Response to Submissions Report

Proposed Port Kembla Bulk Liquids
Terminal (SSD 7264)

8201510305/Report 001 Ver 5

7 April 2016

Figure 2: Sensitive Receptor Locations, including Additional Receptors 15-23 at the Site Boundary

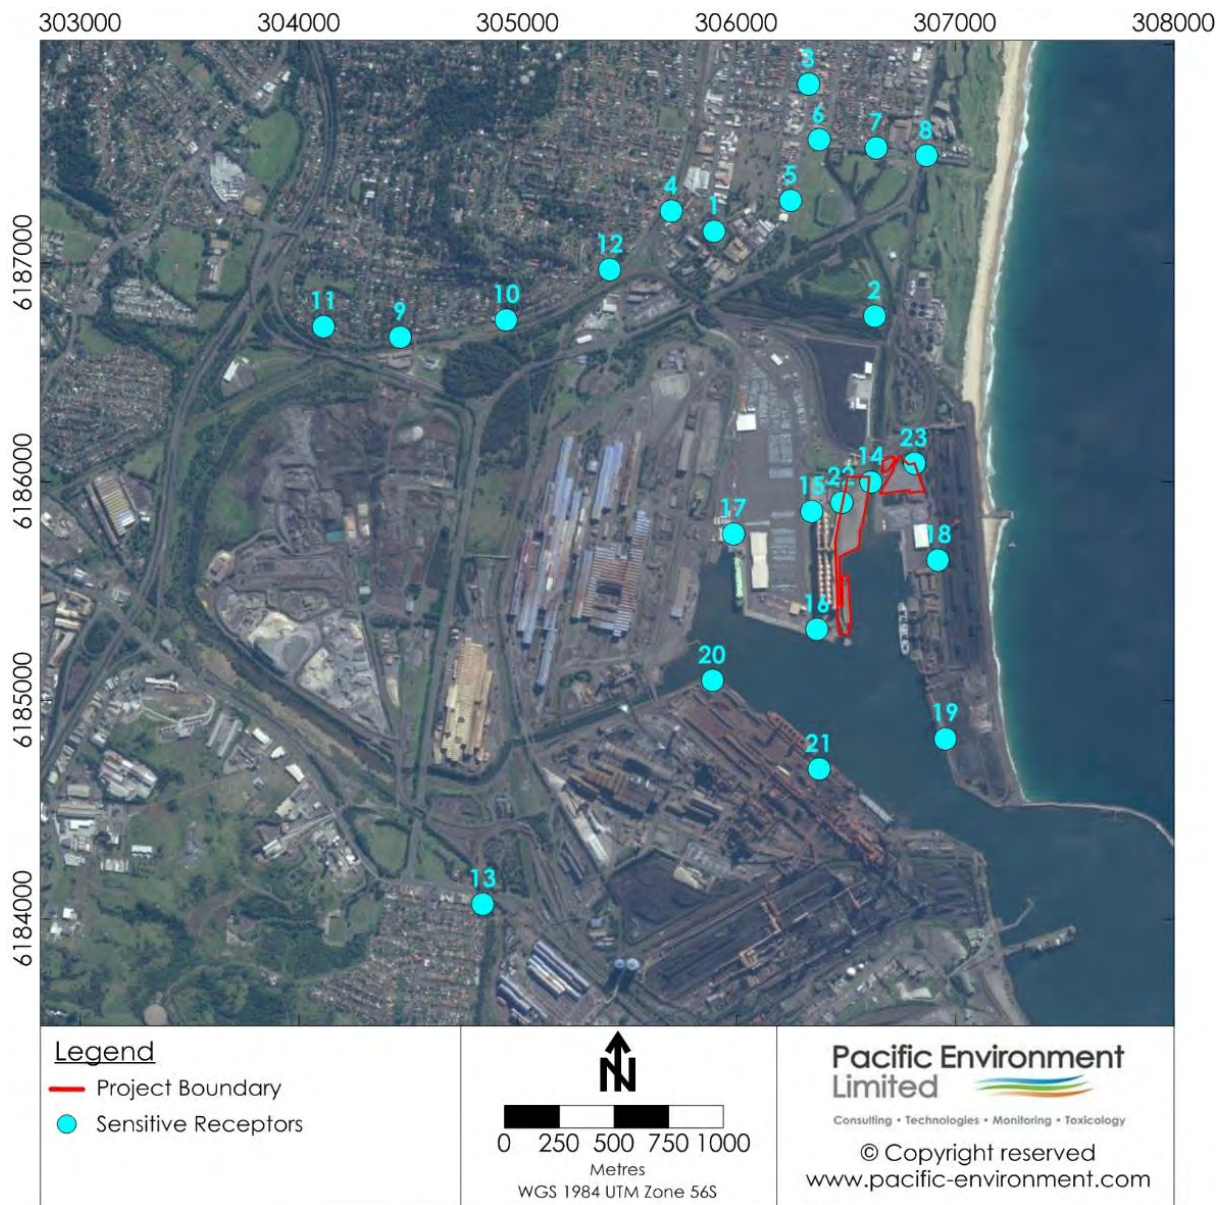
The EPA notes the EPA's Approved Methods defines sensitive receptors as 'a location where people are likely to work or reside' (underlined for emphasis). In addition, offensive odour provisions under Section 129 of the POEO Act apply at and beyond the boundary of scheduled premises. It is recommended that the assessment is revised to assess potential for impacts at and beyond the boundary to determine if management and mitigation options are required.

Appendix B details that additional receptor locations were added to the revised dispersion model to evaluate predicted impacts at and beyond the project boundary. The results indicate that the maximum odour concentrations will be greatest at the project boundary, though these results do not exceed the odour assessment criteria. Notwithstanding these results, an operational odour management plan has been included within the revised mitigation measures detailed in **Table 6-1**.

Finally, and in response to an additional EPA submission, it is noted that revised modelling has evaluated projected impacts at selected points around the site boundary. Additional receptor locations (15 through to 23) have been assessed to determine the impacts at the boundary (or in close vicinity) of the Project as shown **Figure 2**.

As noted in **Section 1.12** and **Figure 2**, additional sensitive receptor locations have been added to the revised dispersion model to evaluate predicted impacts at and beyond the Project boundary. The results of the odour assessment, including these new receptor locations, are presented in **Table 7**.

Figure 3: Annual and Seasonal Windroses (Left: CALMET Generated for AQGHG Assessment, 2009, Middle: Port Kembla, 2013, Right: Port Kembla 2014)

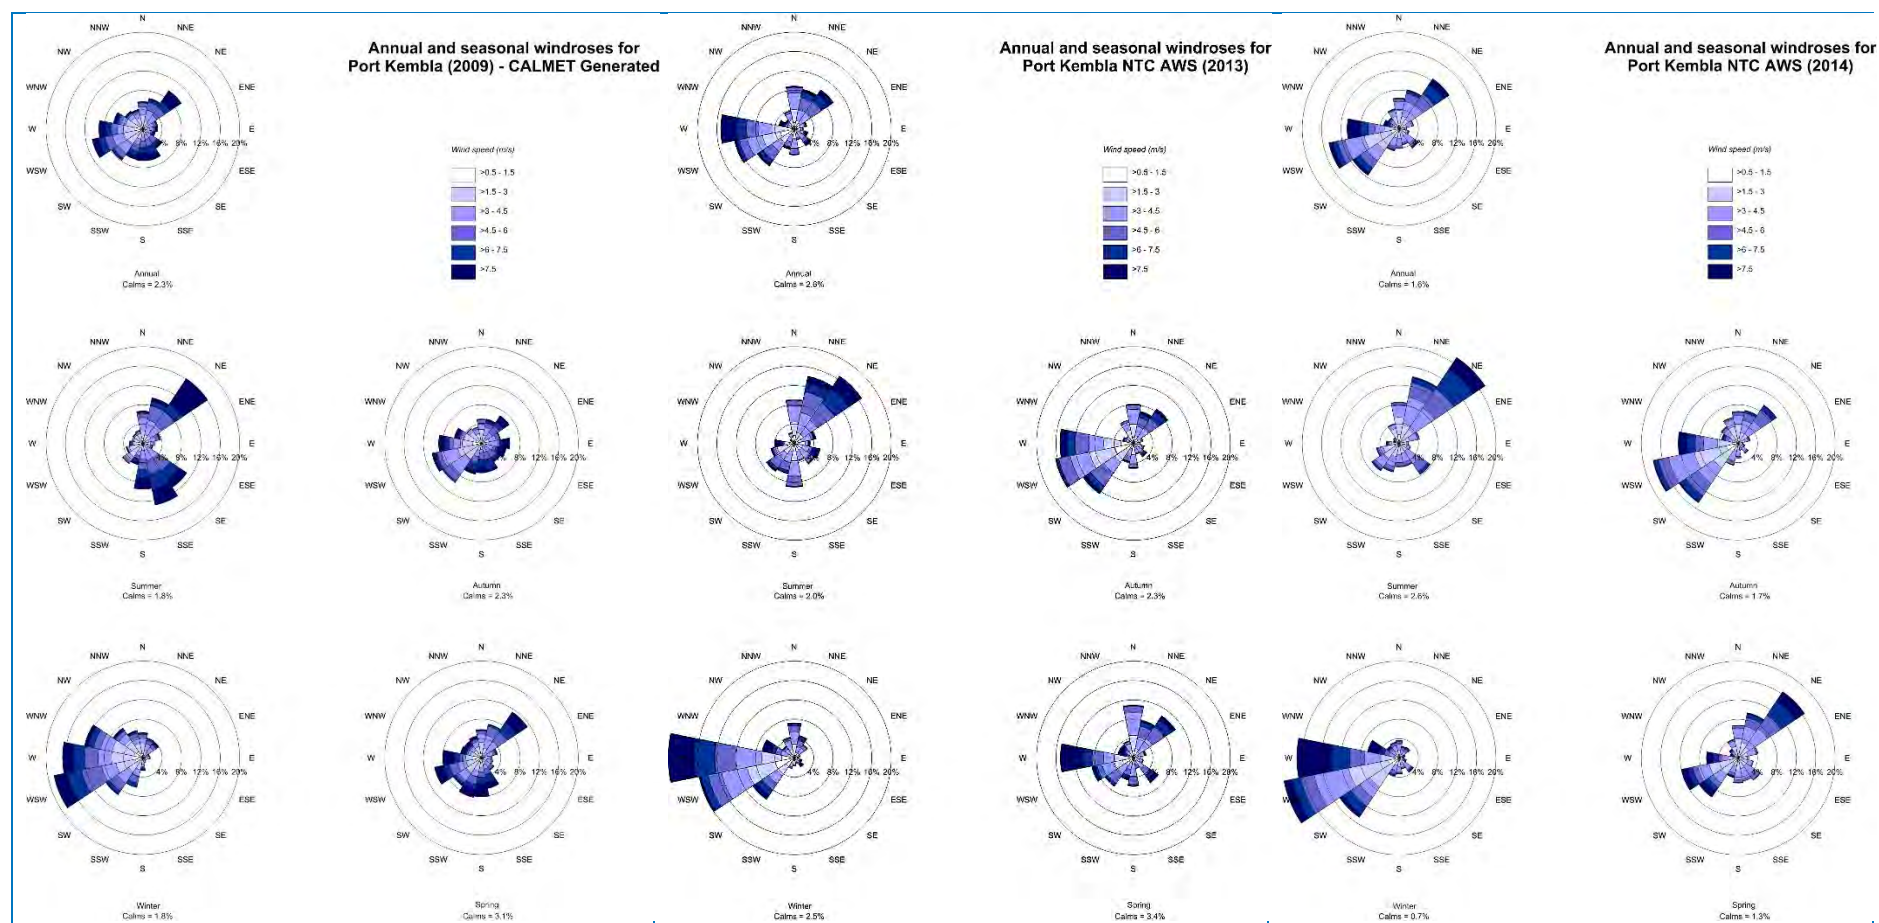
The AQGGA should be revised to include the results of the analysis demonstrating year 2009 is a representative year.

To expand on the analyses provided to date, **Figure 3** presents the CALMET generated windroses for 2009 used in CALPUFF for the dispersion modelling alongside windroses for 2013 and 2014 taken from the Port Kembla NTC AWS, located approximately 2 km south-east of the Project. Alternative years of observations to the CALMET year are presented only as these represent data sets readily available from our internal database.

Observations from the Port Kembla NTC AWS have not been incorporated in the CALMET modelling for the project (since the AWS was only commissioned in July 2009). However, this windrose comparison provides useful validation that the CALMET file used is generally representative of the area. Specifically, the calms and winds from the north to north-east and south to south-west are consistent across both data sets.

Figure 5: Port Kembla Wind Speed Data and Associated INP Limit (5m/s)

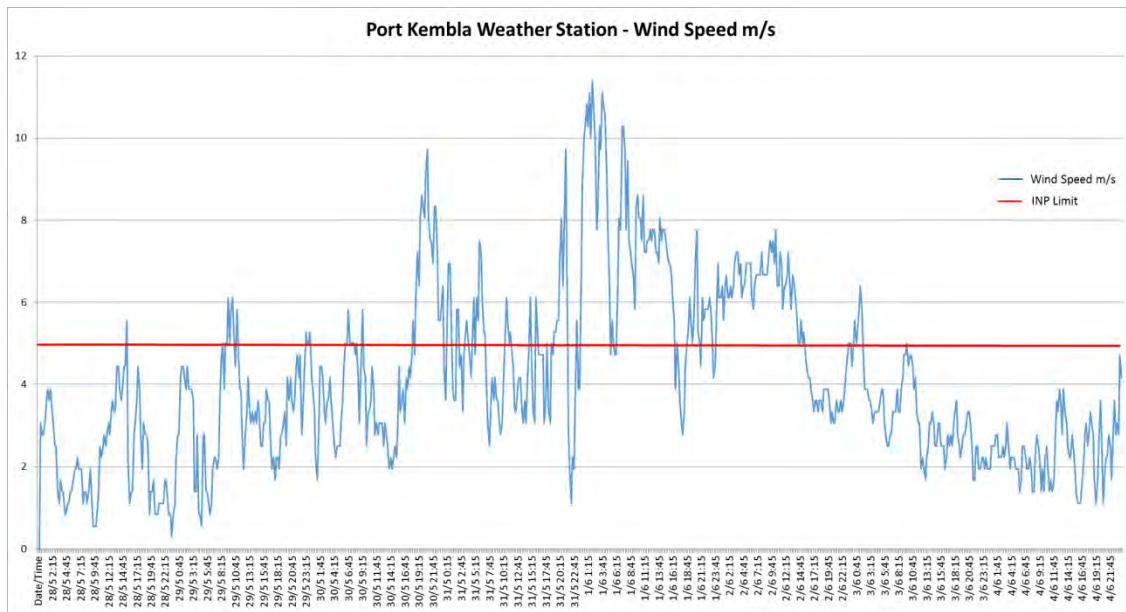
- Provides more detail to support noise monitoring results, such as:
 - noise logger model and date of last calibration
 - photographs of monitoring equipment in place

Figure 5 shows wind data collected over the monitoring interval at Port Kembla and that no rainfall occurred during the monitoring interval. Data was excluded for periods of elevated wind speed where upward trends in noise level were observed in logger data. A graphical representation of the noise logging data is included in Appendix B of the Noise and Vibration Assessment (**Pacific Environment, 2015**).

Figure 1: Pool geometries (a) cylindrical flame (b) cylindrical flame with elongated flame at higher wind speed

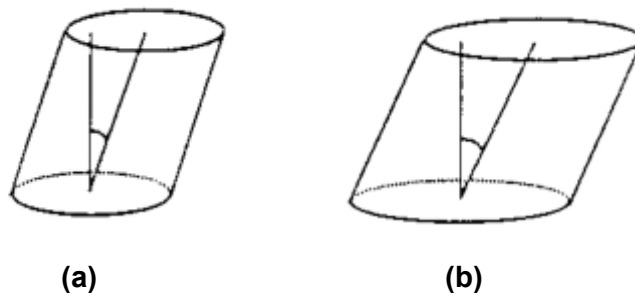
TQ acknowledges in the event of jet and pool fire, only high wind speed (5 m/s rather than 2 or 3 m/s) was considered in the PHA (Appendix D of the EIS). A higher wind speed was used to assess the consequence of a pool fire as the greater speed elongates and can increase the surface area of the flame (see Figure 1 of **Appendix E**). A higher wind speed produces a more conservative result as it results in a higher thermal radiation heat flux at the receptor.

The 5 m/s wind speed was chosen as the basis for consequence modelling of a pool fire. A higher wind speed will elongate the flame giving it an elliptical shape, Ref. (2). Figure 1 shows the pool geometries and cylindrical flame shape at a lower and higher wind speed.

The elongated diameter of the flame can increase the surface area of the flame. The view factor¹ of a fixed receptor downwind of the flame would be greater at a higher wind speed. The receptor would be exposed to a higher thermal radiation heat flux. This would produce a more conservative result.

Figure 11: Site 2 Full Bund fire

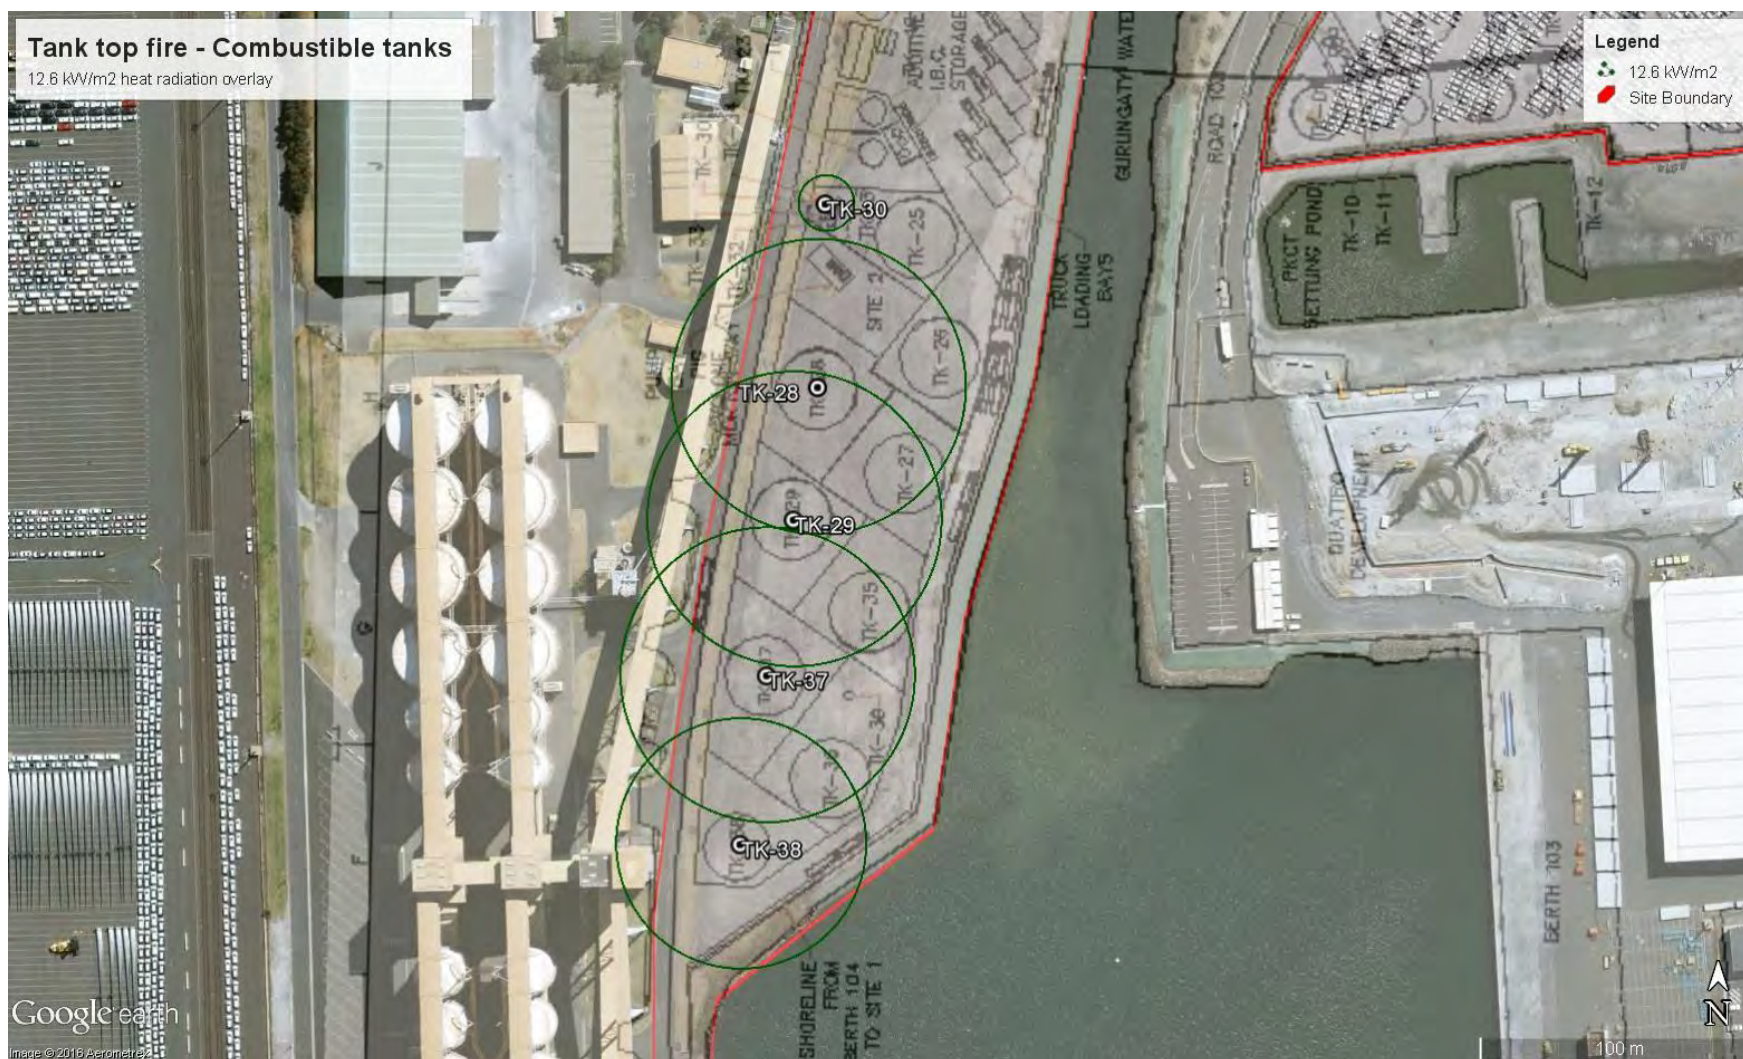
Sherpa recommends due to the rectangular shape of Site 2 and the circular overlays, the distances to heat radiation levels need to be applied along the length of the bund (i.e. from TK-25 to TK-38) for thermal radiation contours at 12.6 kW/m² and 23 kW/m² for a Site 2 bund fire (Figure 13).

Figure 11 show the thermal radiation contour overlays at 12.6 kW/m² and 23 kW/m² respectively for a Site 2 bund fire. Due to the rectangular shape of the site and the circular overlays, the distances to heat radiation levels need to be applied along the length of the bund i.e. from TK-25 to TK-38.

Figure 12: Site 2 Flash Fire – Distance to LFL

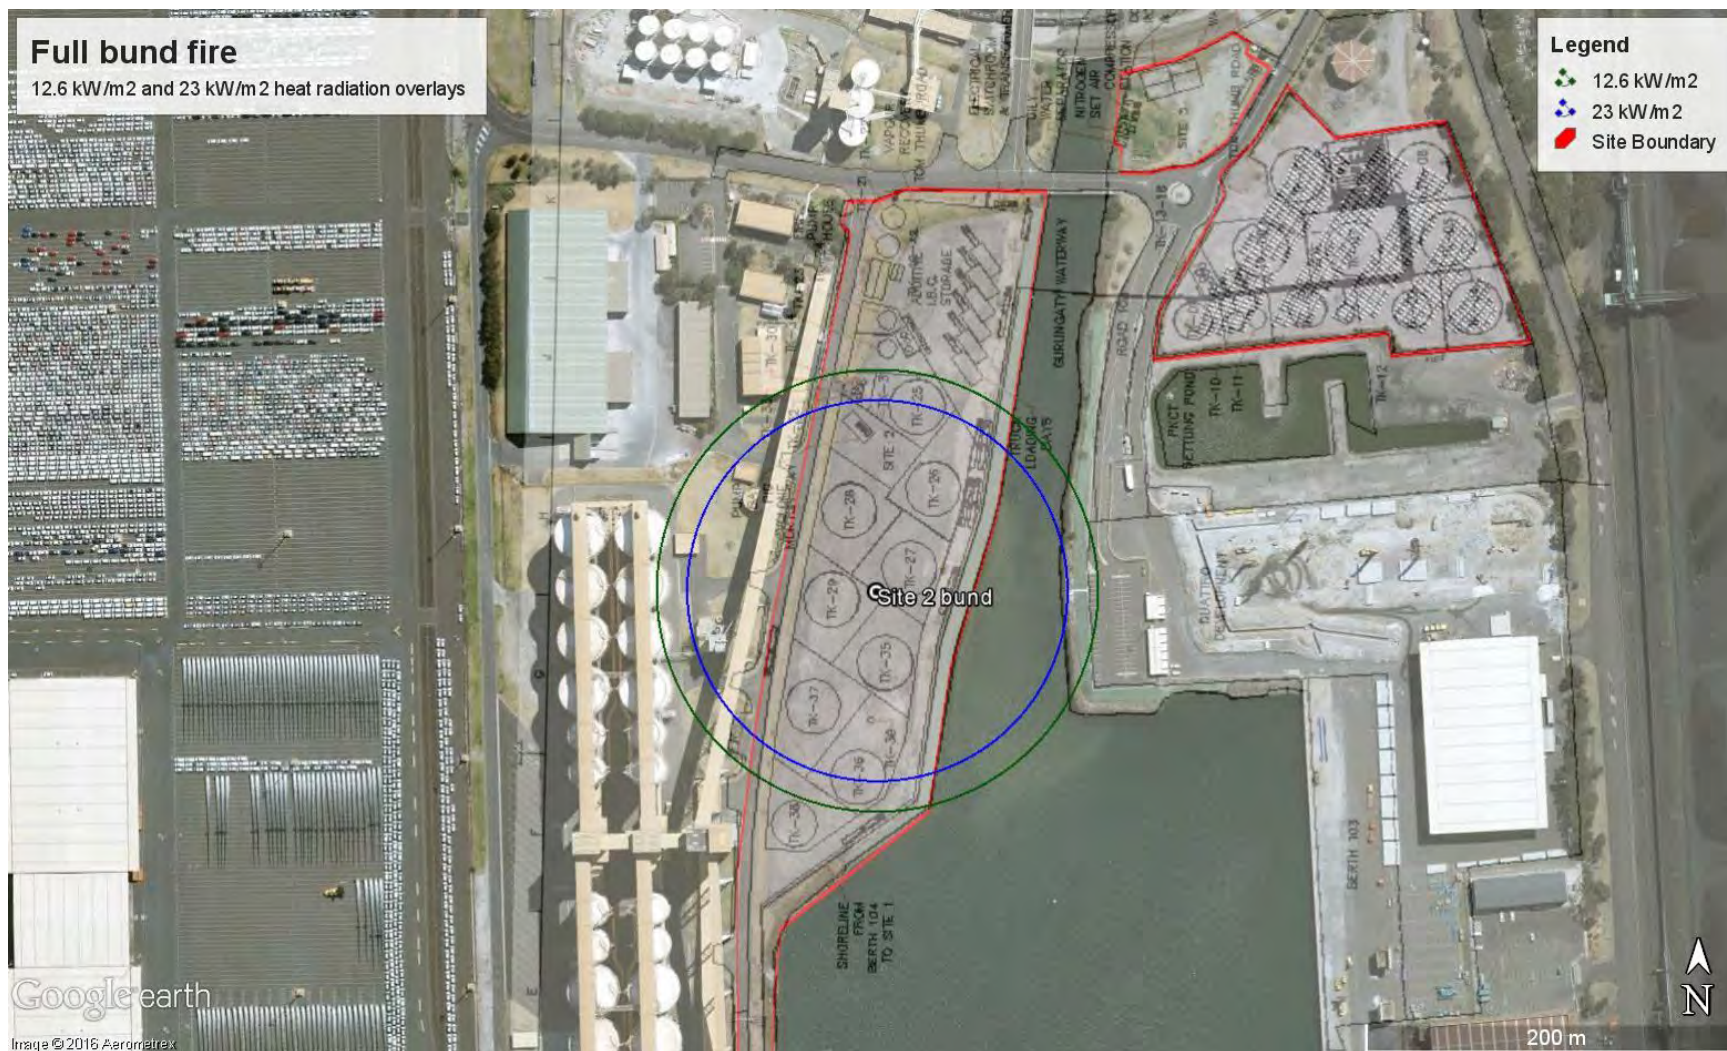
The distances to LFL are reported in Appendix D of the EIS. A plot plan overlay is provided in **Appendix E** (Figure 14) and shows the distances to Lower Flammability Limit (LFL) for three scenarios at F2 conditions. TQ understands the request for a plot plan of 1/2 LFL isopleths for F2 conditions, however, the generation these contours and would provide little benefit due to the uncertainty in modelling results and that the LFL isopleths reach the buildings on the GrainCorp site.

The distances to LFL are reported in Appendix D of the PHA report, Ref. (1). Figure 12 show the distances to Lower Flammability Limit (LFL) for three scenarios at F2 conditions:
